City of Surrey
PLANNING & DEVELOPMENT REPORT

File: 7918-0135-00

Planning Report Date: June 24, 2019

to permit the development of a commercial and office building.

DP SUBMISSION
 Date 30.05.2019
 Project No 7918-0135-00
 12034 88th Ave Surrey, V3W 3J2
 A05 Site Plan

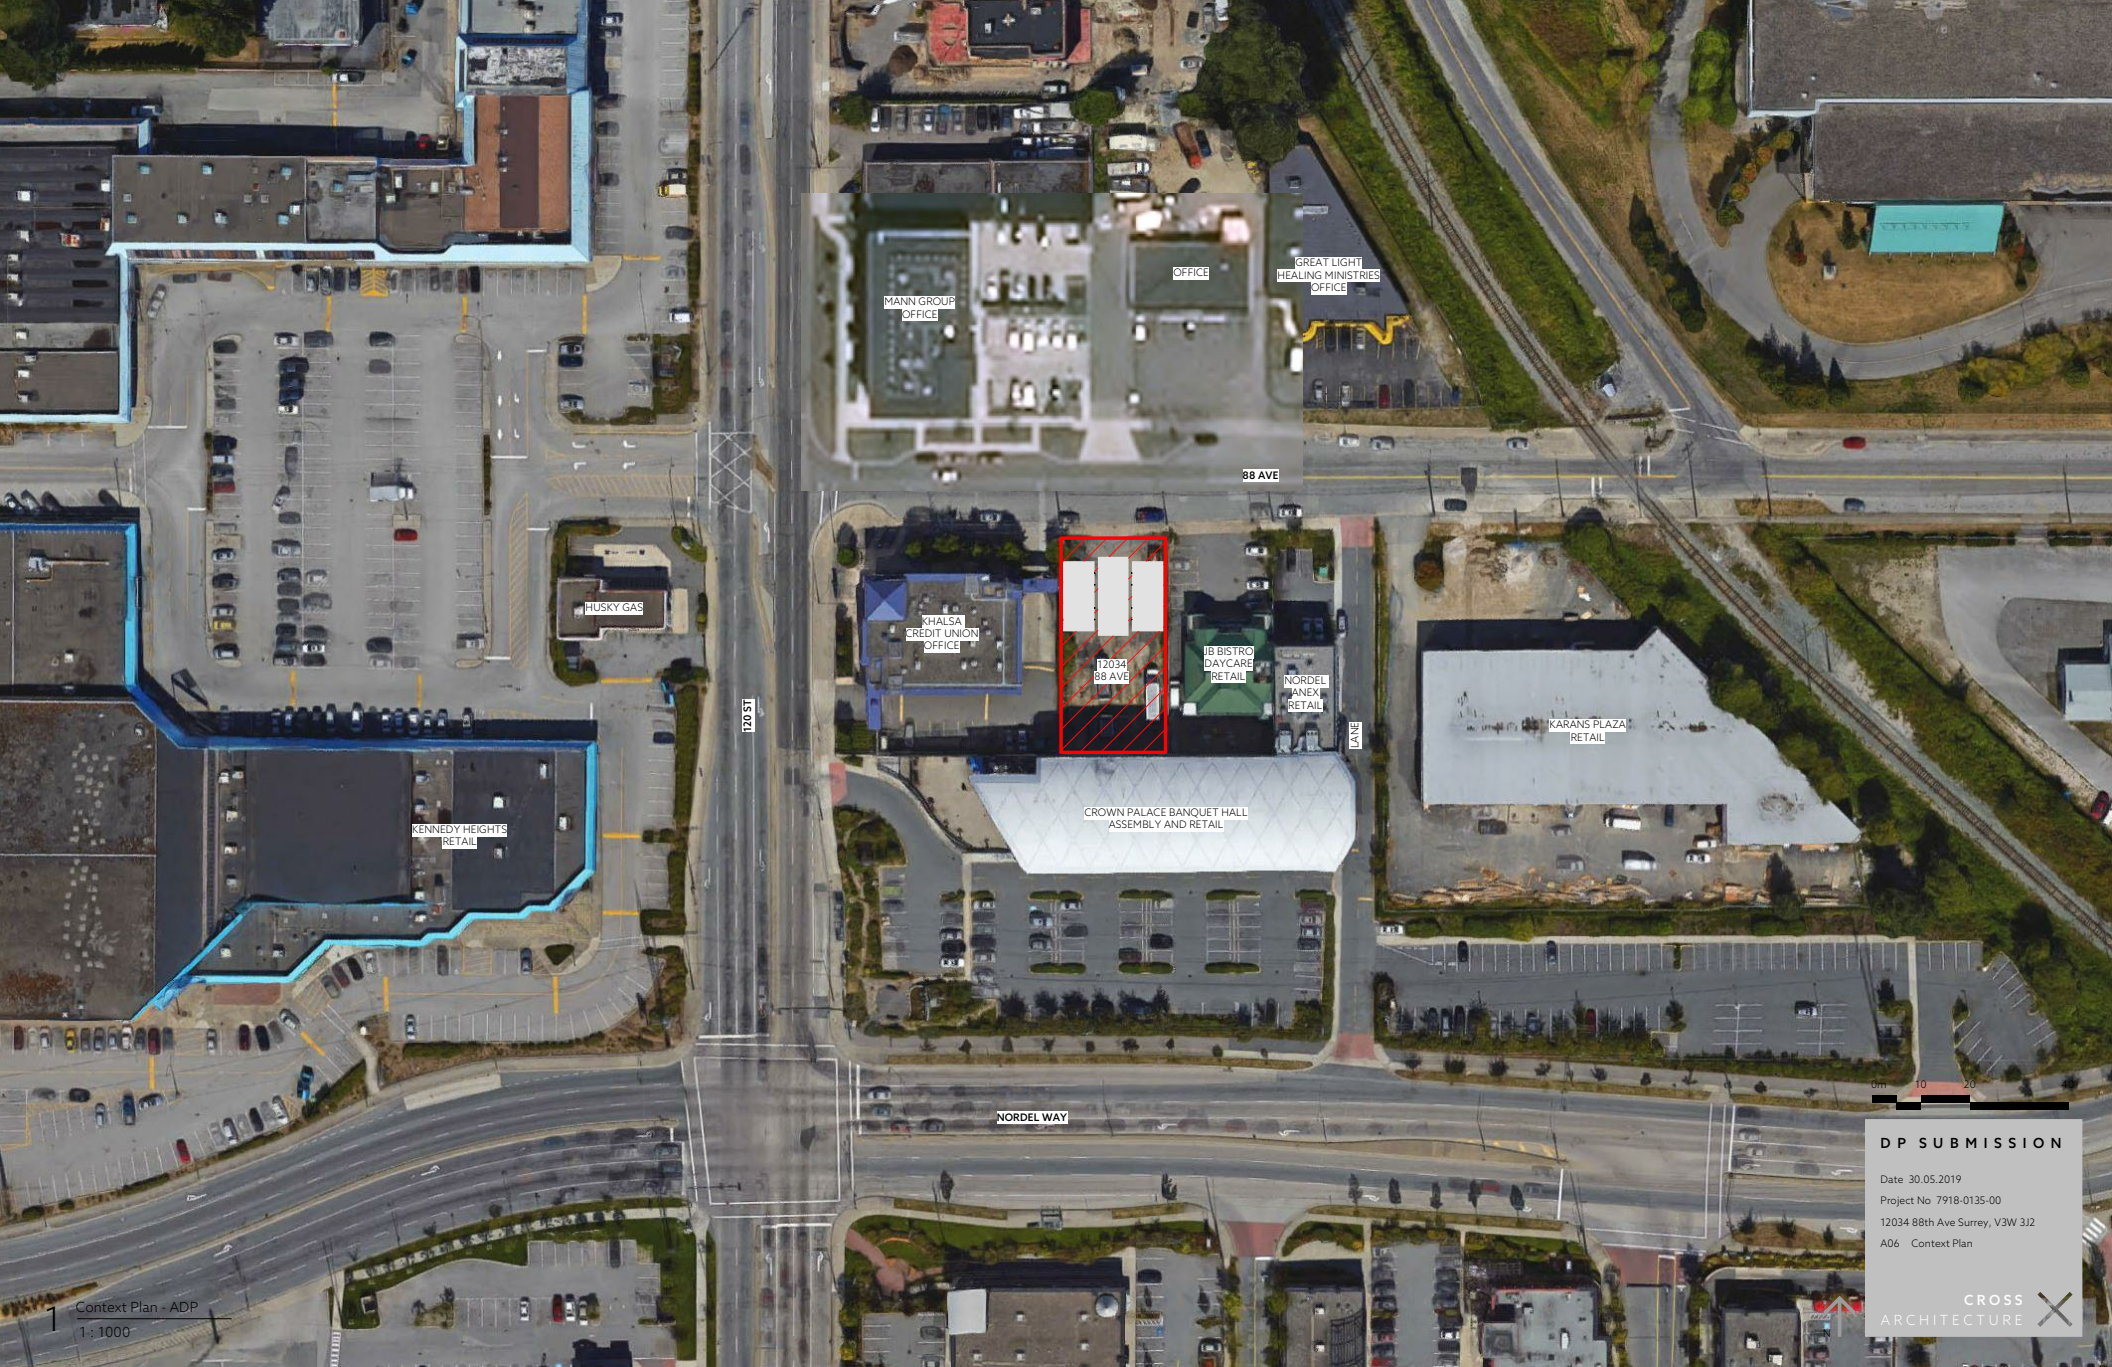
- Consider a safer and more welcoming, pedestrian pathway through drive aisle with more visual differentiation from the driving surface.
A 4" granite edge separates the drive aisle and pedestrian pathway in order to make it safer, visually different, and welcoming. See A05.

- Consider further programming and articulation of other ideas available on the patio.
A communal seating area is proposed. See A04, A12.
- Consider enhancing the front yard landscaping.
Due to the COS civil requirements there will be double the amount of landscaping provided in the city-side front yard. On the site's frontage, we have done exactly as the COS has requested. See A05.

DP SUBMISSION
 Date 30.05.2019
 Project No 7918-0135-00
 12034 88th Ave Surrey, V3W 3J2
 A10 Level 1

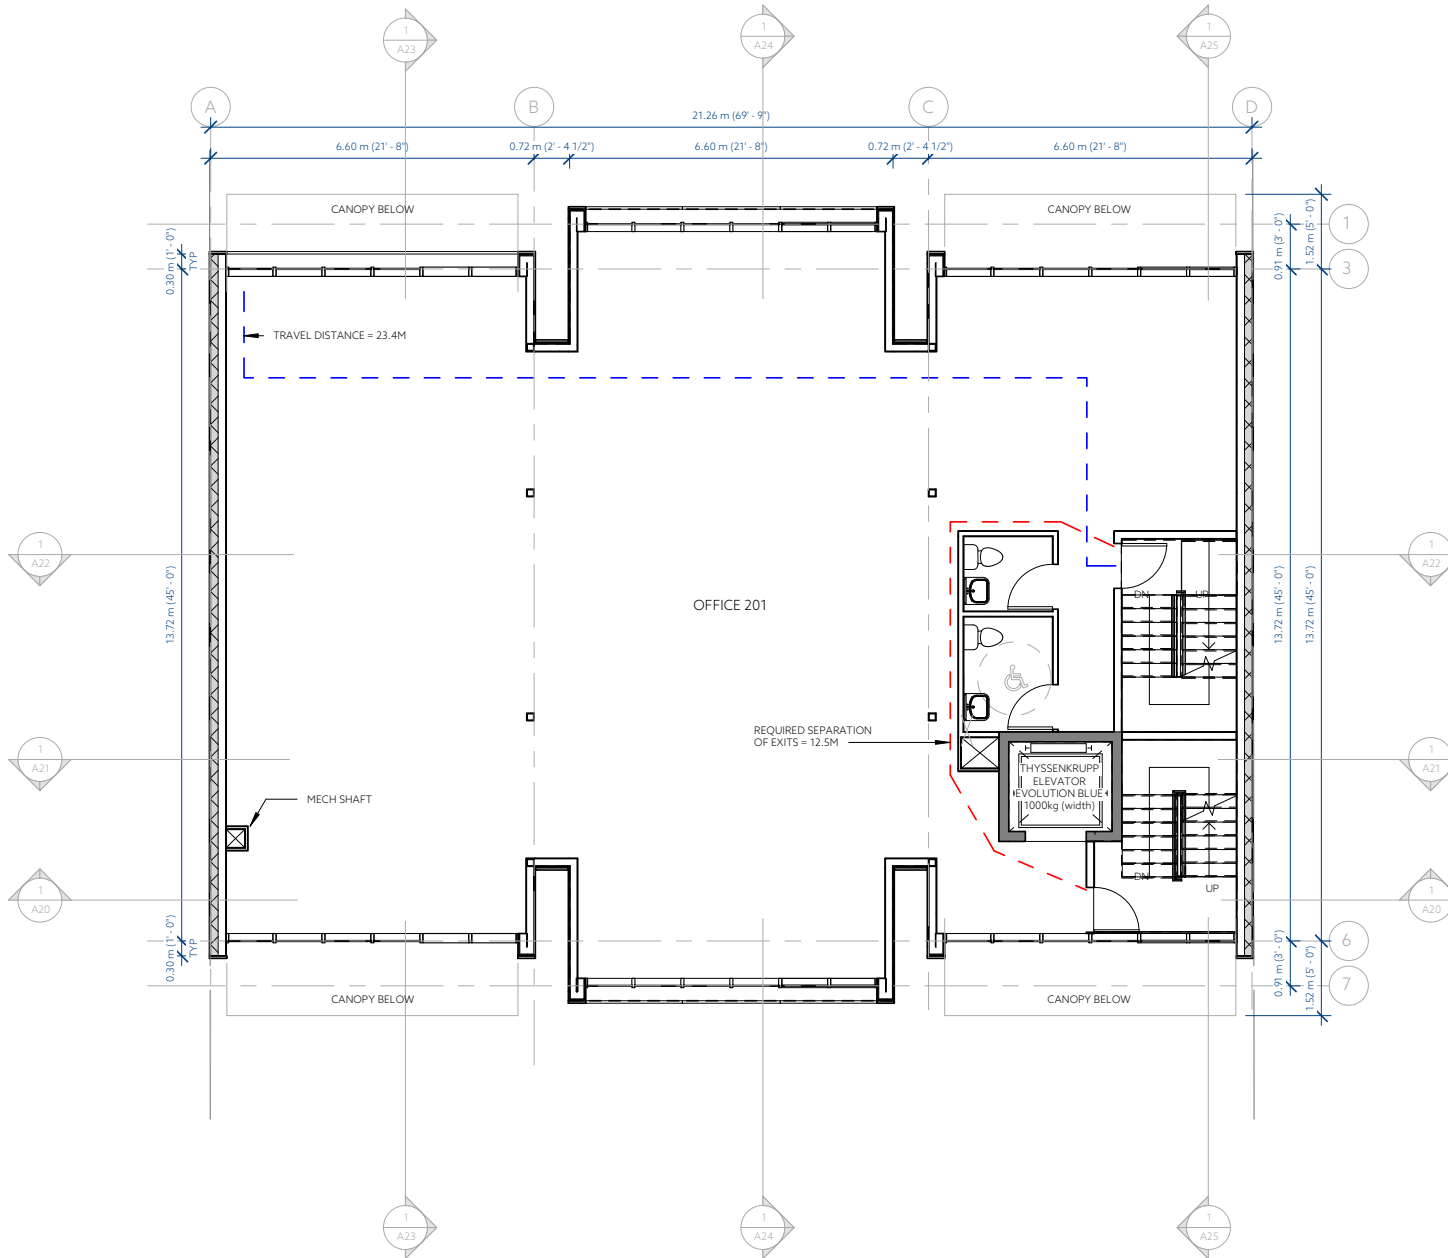
- Recommend prioritizing the front entry-way and pedestrian street experience.
The front entry-way is prioritized by making it pedestrian oriented and visible. Placing the elevator in front would ruin the pedestrian street experience by blocking the CRU from the street. See A10.

1 North Elevation (88 Ave) Context - ADP
1 : 150

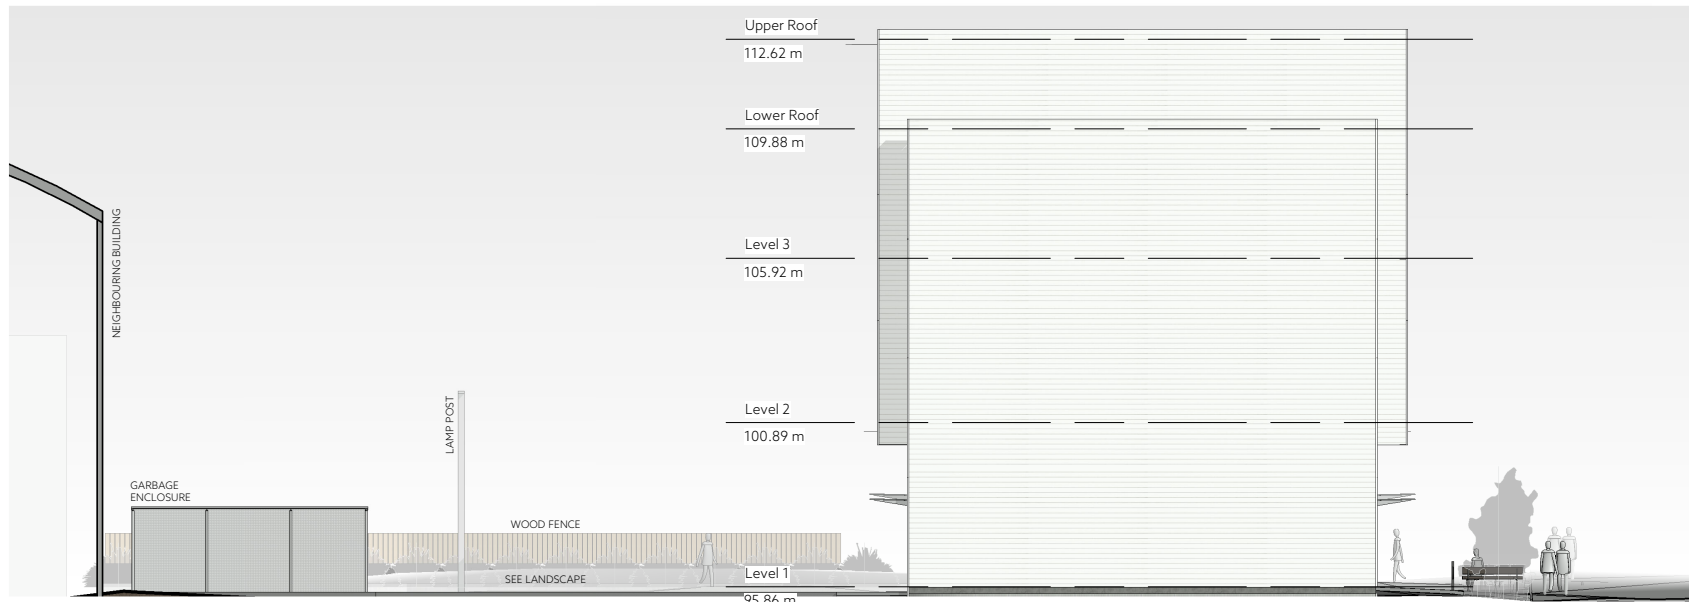
- Consider further variation of the parapets for each block to be more playful.
We propose to raise the uppermost roof 4'-0" (1.22m). See A14 for elevations. This creates better proportions and "a more playful difference in heights." - Robert Drew
- Consider further exploration of the interface where the building hits the ground plane.
The vertical fascia will terminate into the concrete walkway. A white concrete strip will wrap the inside of the projecting walls, mimicking the bottom of the rectangular form. See A05.
- Consider pure forms and clean aesthetics to manage signage, lock boxes or other post-occupancy add-ons, which should be integrated.
Lock boxes will be located at the building rear. Sizes and locations of signage are regulated on A27.

- Consider alternatives to the dark tinted windows, such as fritted glass.
We have revised the dark tinted windows to be clear glazing. This brightens up the building and interior spaces. See A14.

Date: 30.05.2019
Project No: 7918-0135-00
12034 88th Ave Surrey, V3W 3J2
A17 Elevations

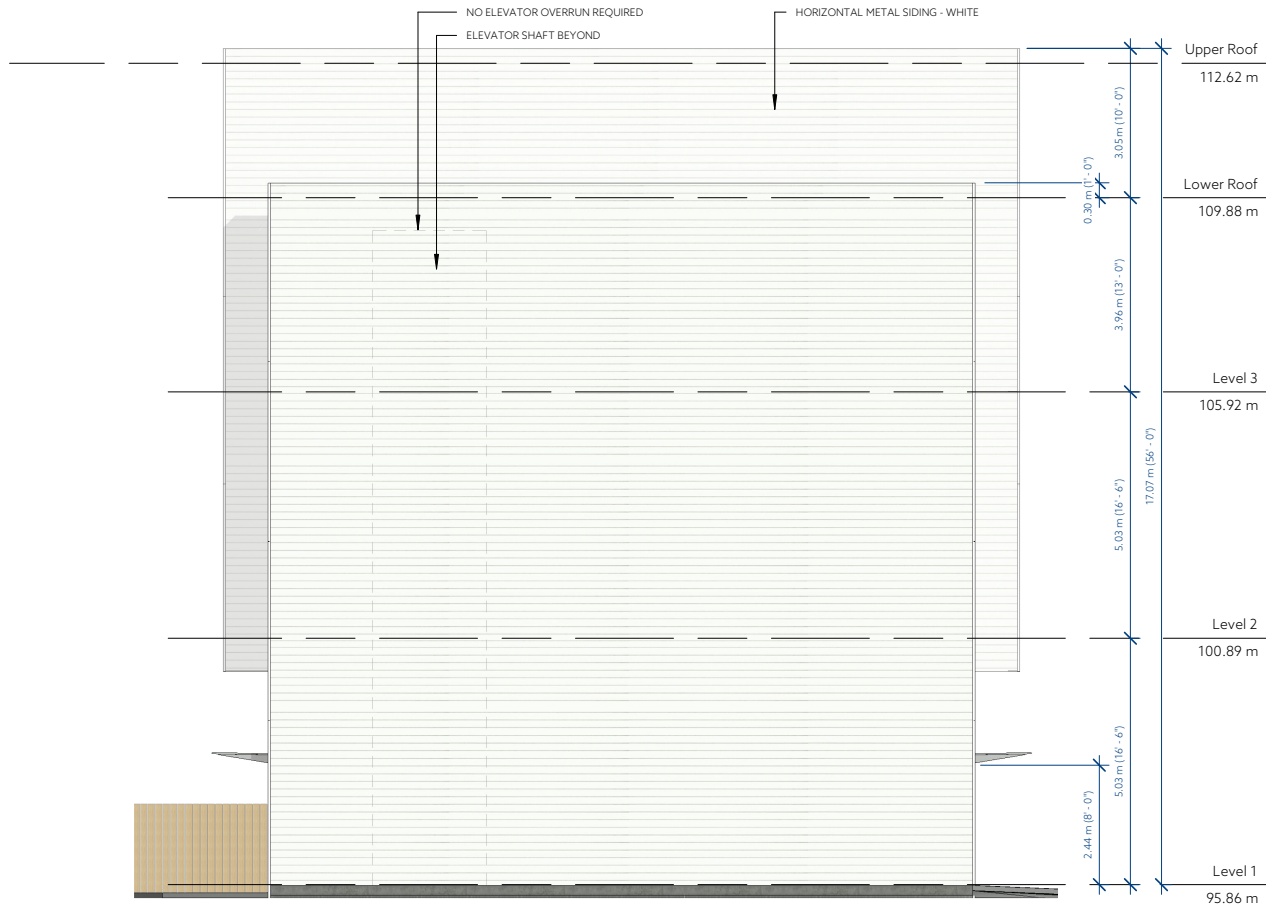
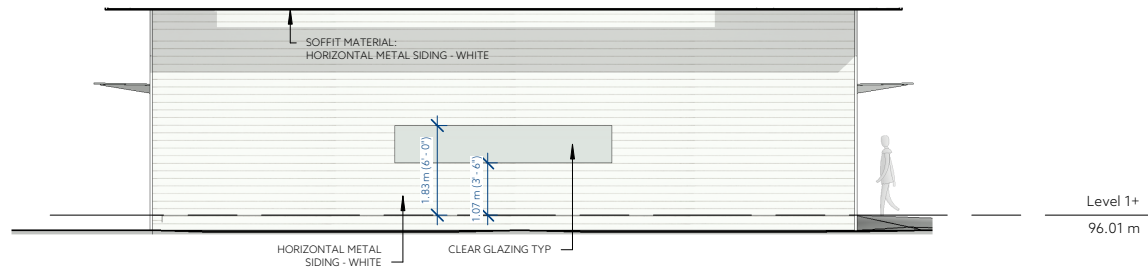
- Consider adding windows along the driveway facade through the vehicle parkway, such as across each CRU or at its corners.
We have added windows as desired. See sheets A02, A17, A19.

A26 Facade Details

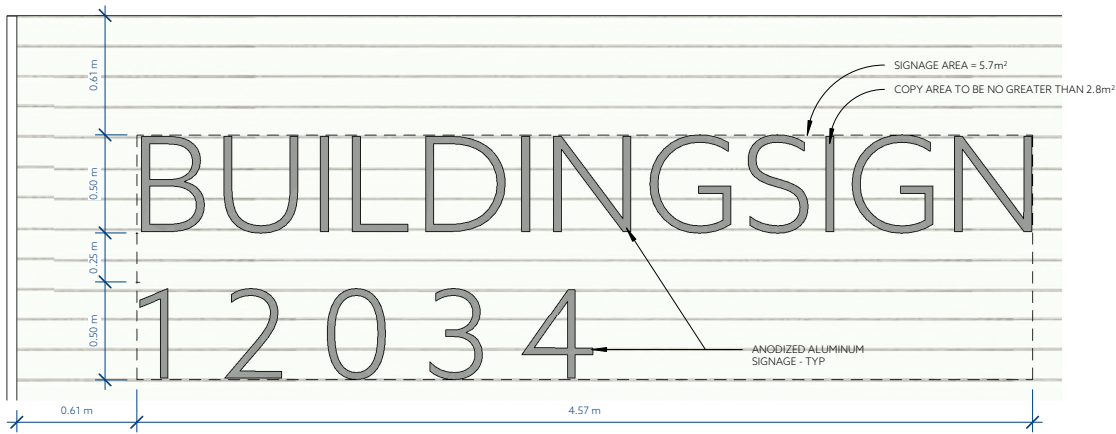
Members expressed concerns that there is not enough details in the circulation, facade and street elevations.

We have provided an additional fascia detail. See A26

Date: 30.05.2019
Project No: 7918-0135-00
12034 88th Ave Surrey, V3W 3J2
A27 Signage

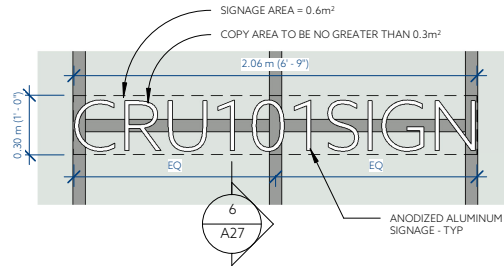
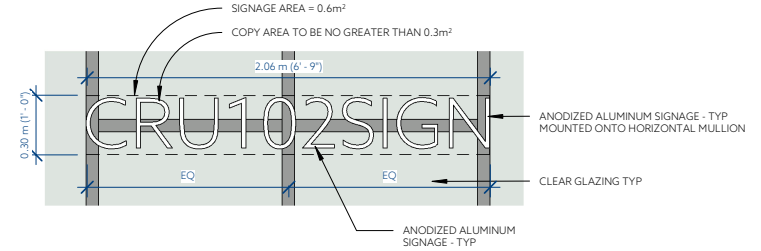
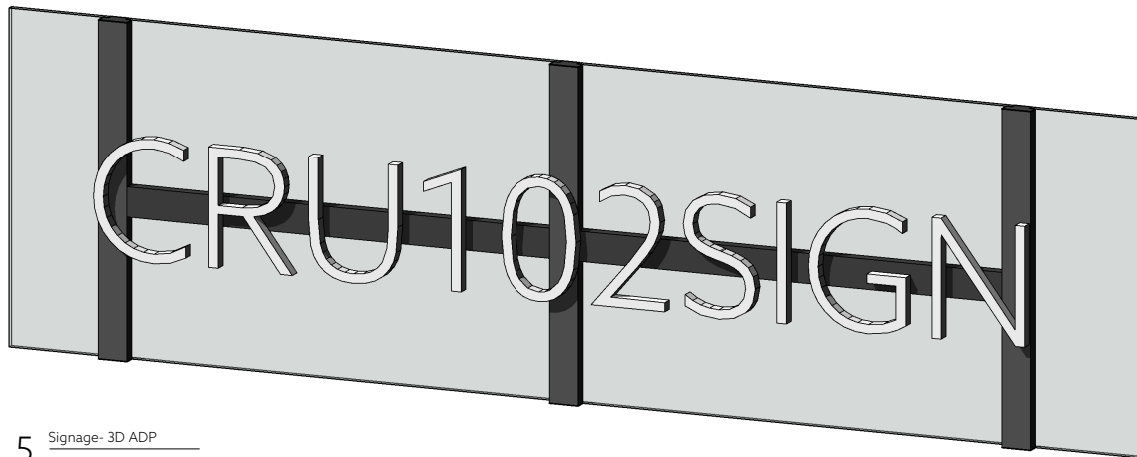
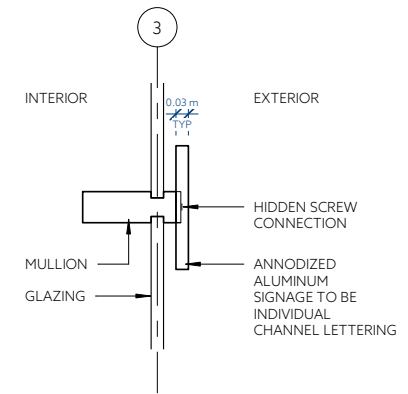
- Explore ideas for the exterior side wall signage.
Proposed signage on sheets A27. We have also added wayfinding signage. See A02, A19.
- Consider the opportunity for retail spaces to have pedestrian frontage.
Yes. All retail spaces have pedestrian frontage. See A05.
